Economic Commission for Europe**Inland Transport Committee****World Forum for Harmonization of Vehicle Regulations****Working Party on Lighting and Light-Signalling****Eighty-fourth session**

Item 7 (a) of the provisional agenda

Other UN Regulations:**UN Regulation No. 86 (Installation of lighting and light-signalling devices for agricultural vehicles)****Revised proposal for a draft amendment to UN Regulation No. 86****Submitted by the experts from the European Agricultural Machinery Association***

Figure 1

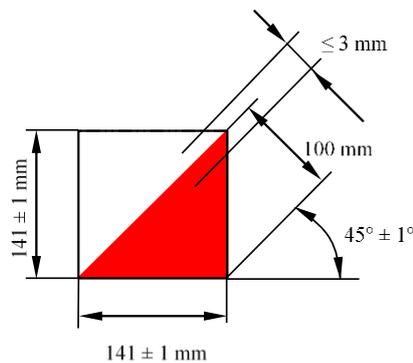
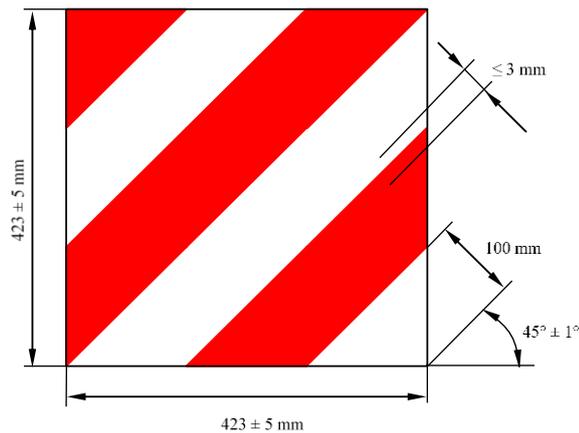
Annex 6,

Paragraph 1.1, amend to read:

"1.1. Signalling panels and signalling foils shall have the following dimensions:"

Annex 6,

Paragraph 1.1, Table 1, amend to read:

Signalling panel or signalling foil	<i>a</i> [mm]	<i>b</i> [mm]	Surface [cm ²]
Form A	423 ± 5	423 ± 5	$\geq 1,790$
Form B	282 ± 5	282 ± 5	≥ 795
Form R1	282 ± 5	423 ± 5	$\geq 1,193$
Form R2	423 ± 5	282 ± 5	
Form L1	141 ± 5	846 ± 5	$\geq 1,193$
Form L2	846 ± 5	141 ± 5	
Form K1	141 ± 5	423 ± 5	≥ 596
Form K2	423 ± 5	141 ± 5

Deviations from the specified formats are permitted, provided that:

- (a) The visible surface of each panel or foil shall be at least equal to 4 basic standard areas and
- (b) Each panel or foil shall comprise at least 3 entire basic standard areas.

If the structure, design or the operational use of the vehicle makes it impossible to comply with such a requirement, each panel or foil may be split into 2 parts as long as each part comprises at least 2 entire basic standard areas."
